## CORRIGENDUM-II

**Subject:** Design and Construction of Elevated Viaduct of Length 6.836 KMS From CH: 590 To CH: 5809, CH: 6000 To CH: 7100 and CH: 7183 To CH:7700 Between Prajapati Nagar To Sitaburdi And ROR Near Anand Talkies, Viaduct & Ramp Near Ramjhula, Ror Near Prajapati Nagar and Viaduct of Length 1.050 KMS From CH :(-)496 To CH: 90.962 and CH: 126.962 to CH: 590 on BOQ Basis.(Reach-4)

**Tender No:** - NIC-09/2016 (ICB)

**Date:** - 17/01/2017

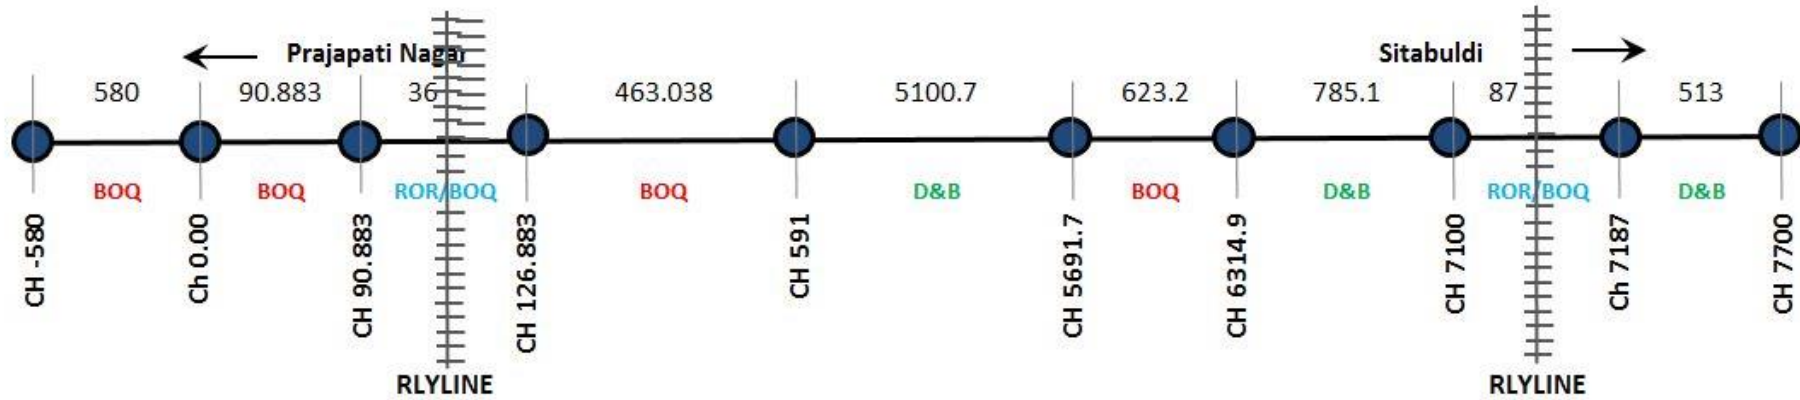
83			Please refer Drg. no. RITES/UT/CO/NAGPUR/IC/EW/PNGR – SB/2015: Sheet 2 : The design and built portion starts from Ch. 590 as per scope of work. However as shown in Sh. 2 the piers in BOQ portion are given at Ch. 593 (EP-47) & Ch. 568 (EP 46). We presume that common pier at Ch. 593 is to be considered in D&B scope and superstructure from Ch. 568 to Ch. 593 in BOQ scope. Kindly confirm		It is to confirm that EP-47 shall be treated as common pier and is to be considered in D&B scope. However, superstructure towards Ch.568 is to be considered in BOQ.
84			Also in Sheet 2 pier location are given from upto EP55 beyond Ch. 590. Are these mandatory locations?		We confirm that these are mandatory location.
85			We have received drawings upto Sheet 6 i.e. Ch. 3800 alignment drawings for further portion are awaited. Even in these portions there will be		We confirm that

common piers, in which scope BOQ or D & B may be confirmed.		<ul style="list-style-type: none"> <li>i. ROR 83m span: - Both piers of 83m span are common piers and considered in BOQ portion</li> <li>ii. The common piers at chainage 5691 and 6315 are considered in BOQ portion.</li> </ul>
86			Can audited balance sheets for the 5 years from 2010 to 2016 be permitted?		We confirm that the audited balance sheet for 5 years from 2010 to 2016 are permitted.
